M E M O R A N D U M

TO: Parks and Recreation Board

SUBJECT: Construction of single-slip boat dock, at 1600 Rock Cliff
File # SP-93-0019DS

PROFILE (A-A) EXISTING

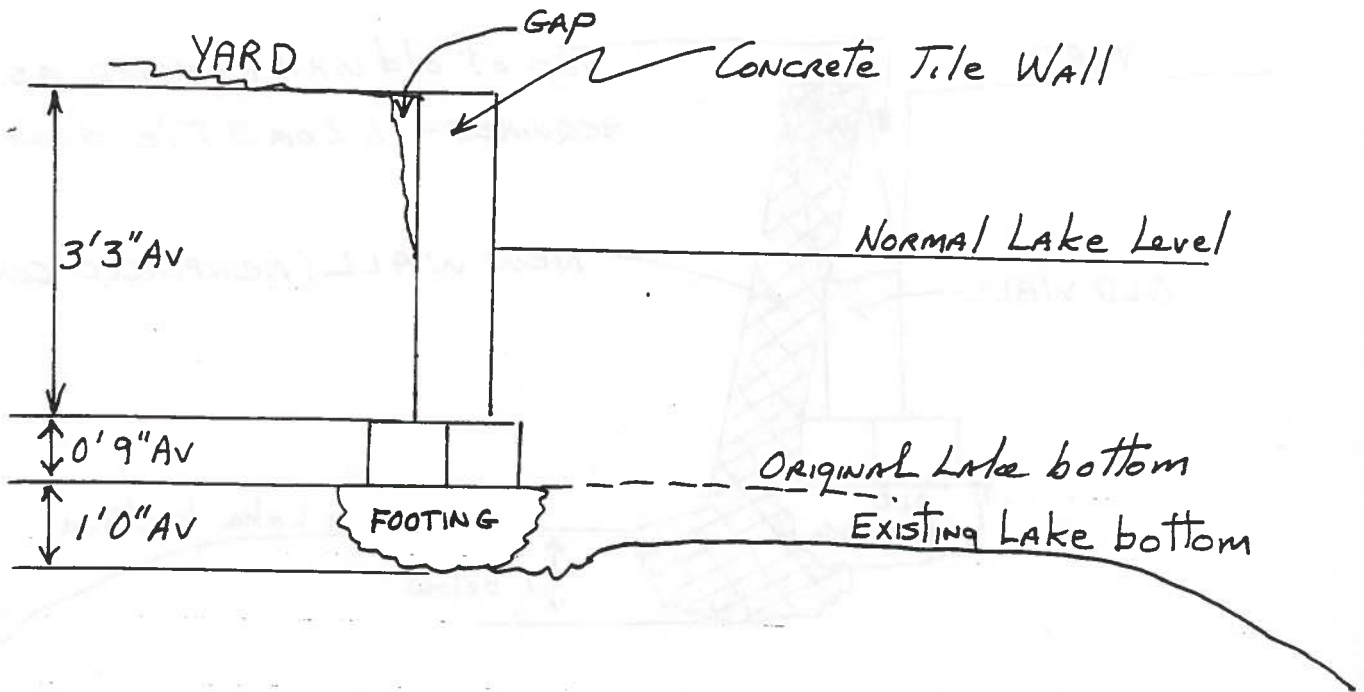
1. Footing scoured out on Lake side.
2. Wall cracked
3. Wall forward of original location

PROFILE (A-A) PROPOSED

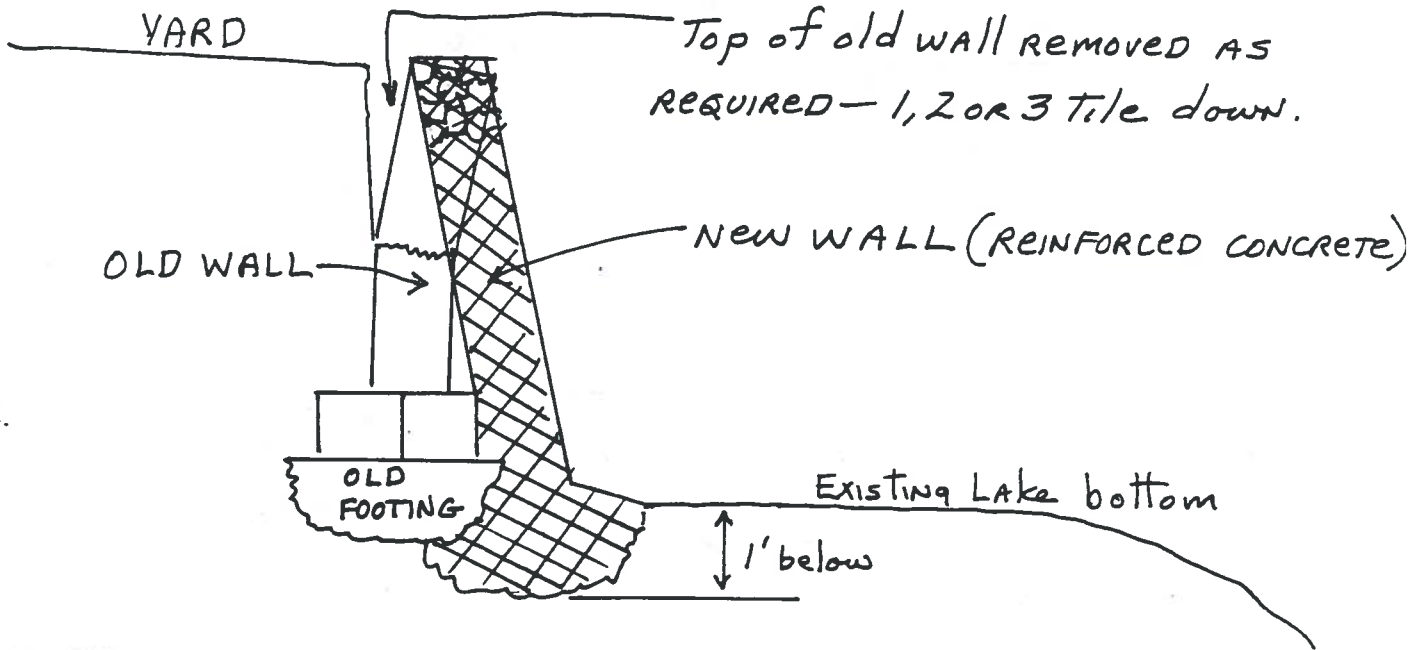
No 4 Steel - vertical - horizontal on 1' center
DRILL and pin new footing to old footing.
Five deadends to new wall
